SERVICE INSTRUCTION MS 14-2009E

Utfärdare Issued by Aussteller Bertil Nyström	Datum Date Datum 2009-09-22	Produkt Product Produkt Scando 450 and Scando 650
Från maskin nr. From machine No. Von Maschine Nr. All	Till To Zu -	Berör/Concerns/Betrifft Cage door magnet

Information about cage door magnet, with part No. 3002143-103

Visible differences between new and old version :

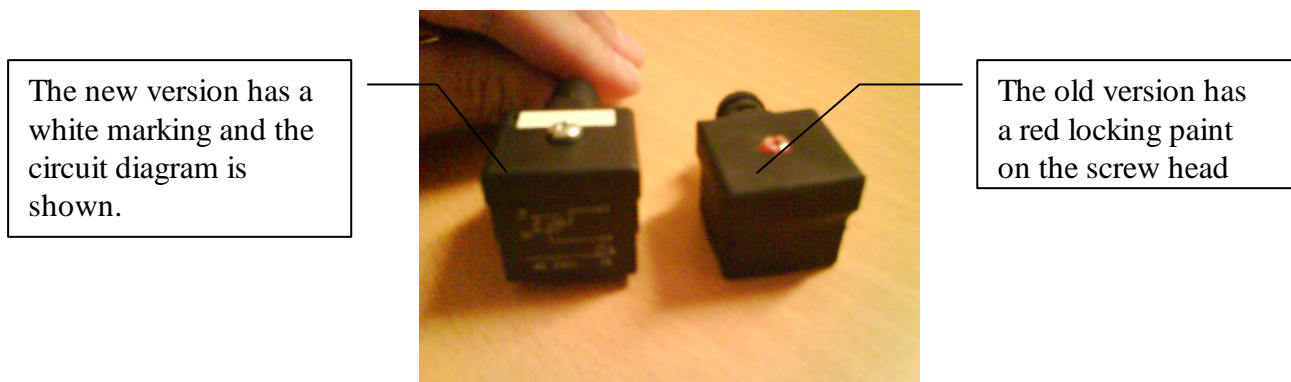
On certain occasions malfunctions have occurred on this magnet. The reason for this was that the contact with the built-in rectifier on the magnet was burnt.

On newer magnets a new contact with rectifier and cable has been applied. The part No. 3002143-121 is the same as before.

The new contact has a better electrical insulation and resists larger voltage variations.
